### THE SERVICED GRID CODE – ISSUE 3 REVISION 29

## THE GRID CODE – ISSUE 3 REVISION 29

### SUMMARY OF CHANGES

- **B/08** – Grid Code requirements for Power Park Modules – Voltage Control and Reactive Power

Figure 4

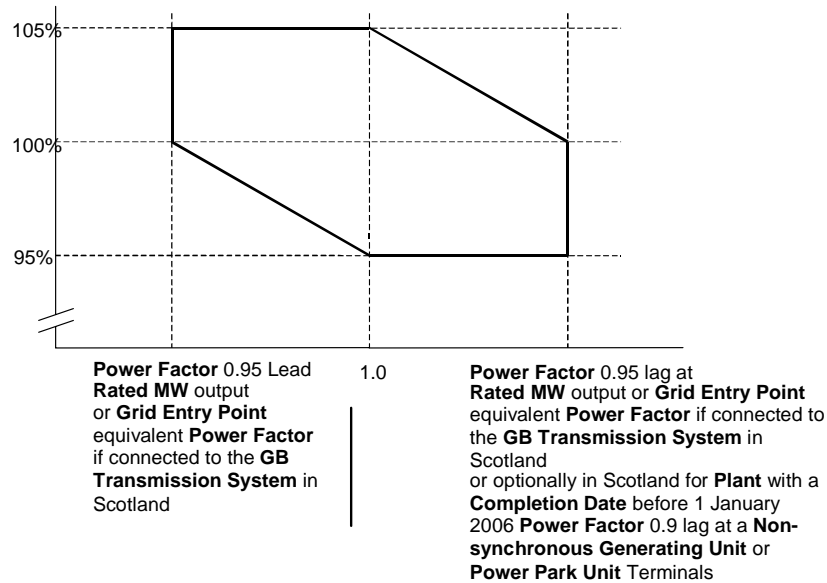
- Minor changes to the diagram in CC.6.3.4 to clarify that for Generating units or Power park Modules in Scotland the reactive power capability requirement may be specified at the HV side of the transformer rather than at the Grid Entry Point and thus at the Grid Entry Point an equivalent reactive range needs to be derived.
- Amendments to CC.A.7.2.2.4 to clarify that the relaxations specified in CC.6.3.4 apply GB-wide and not just in England and Wales.
- Amendments to CC.A.7.2.2.7 to clarify that non-synchronous generating units, , DC Converters or Power Park Modules must meet obligations with regard to reactive current rather than reactive power for voltage rises at the Grid Entry Point above 105%.

At the **Grid Entry Point** the **Active Power** output under steady state conditions of any **Generating Unit**, **DC Converter** or **Power Park Module** directly connected to the **GB Transmission System** should not be affected by voltage changes in the normal operating range specified in paragraph CC.6.1.4 by more than the change in **Active Power** losses at reduced or increased voltage. The **Reactive Power** output under steady state conditions should be fully available within the voltage range  $\pm 5\%$  at 400kV, 275kV and 132kV and lower voltages, except for a **Power Park Module** or **Non-synchronous Generating Unit** if **Embedded** at 33kV and below (or directly connected to the **GB Transmission System** at 33kV and below) where the requirement shown in Figure 4 applies.
